Regarding: Durgin Square, 1600 Woodbury Ave

RJ O'Connell & Associates, Inc. has summarized the following comments received by email on January 7<sup>th</sup>, 2020. We have reviewed the comments listed below in italics with responses following:

Subject: Traffic Evaluation - Durgin Square Portsmouth, New Hampshire

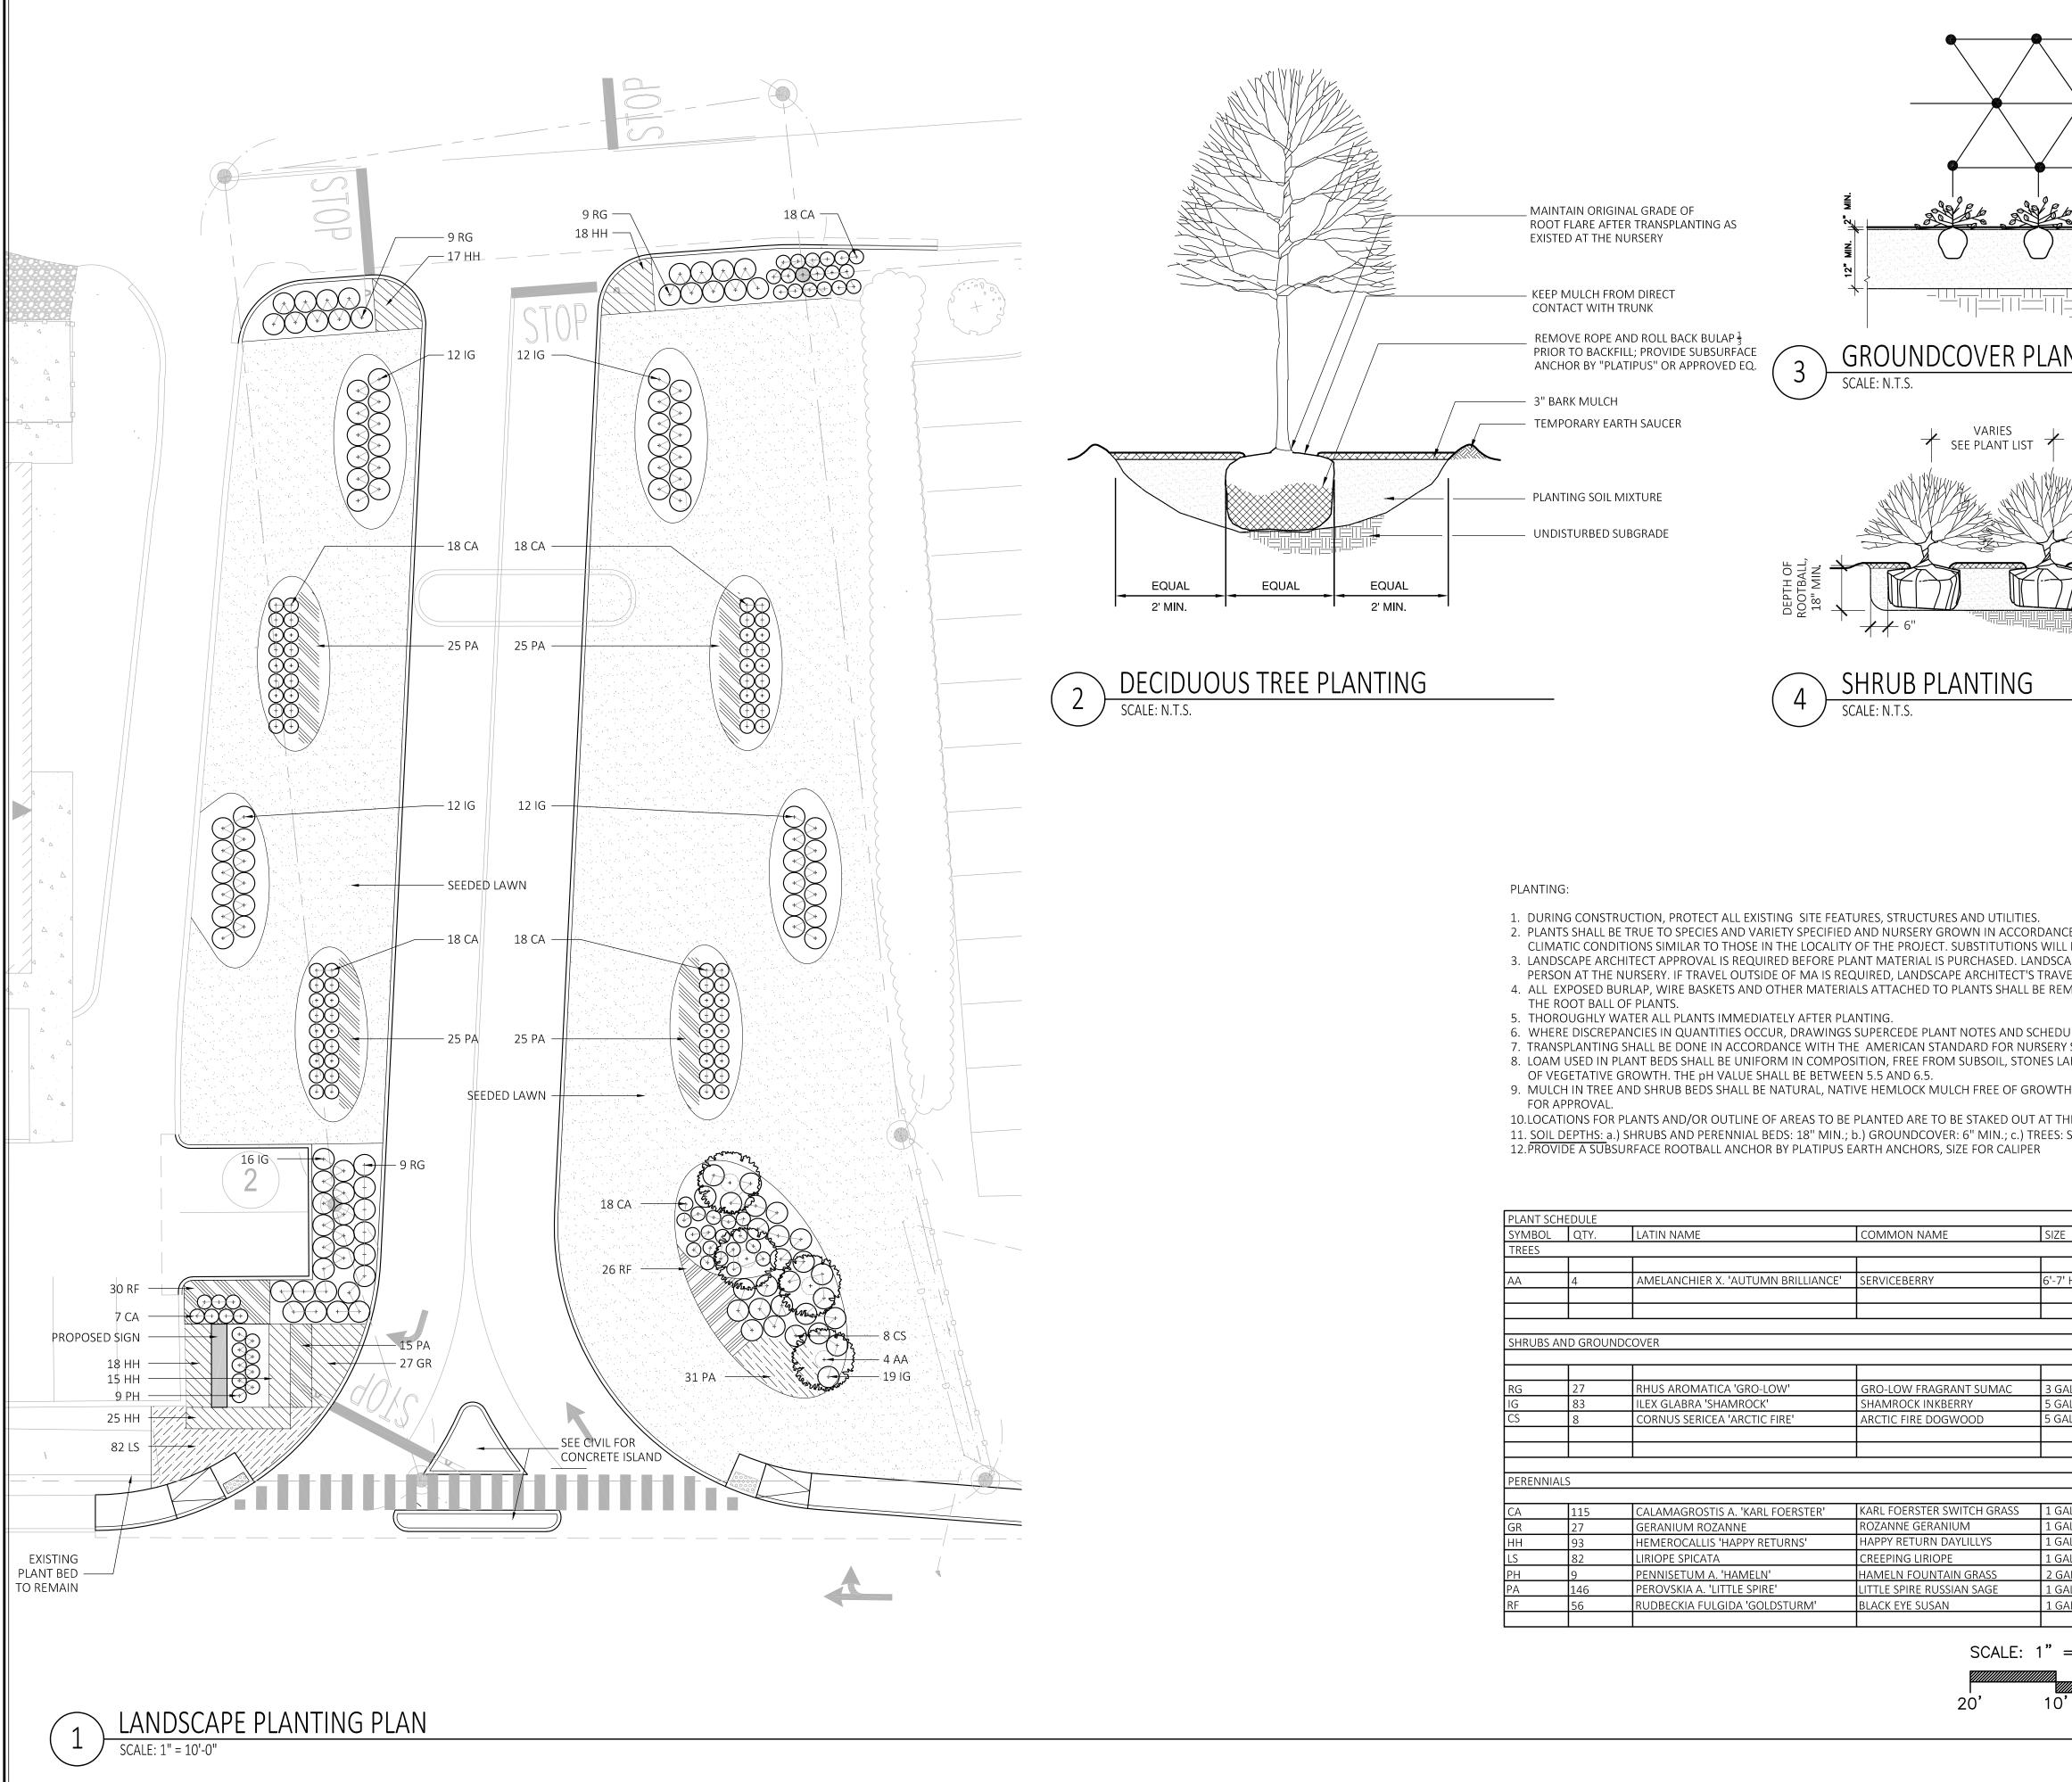
10. To improve the appearance, character and reduce the pervious material on and adjacent the site the parking areas along the proposed driveway should be removed and replaced with trees and other landscaping.

## **Response:** The driveway has been reconfigured to remove parking areas and the proposed open areas will be landscaped. Refer to Drawing L-1.
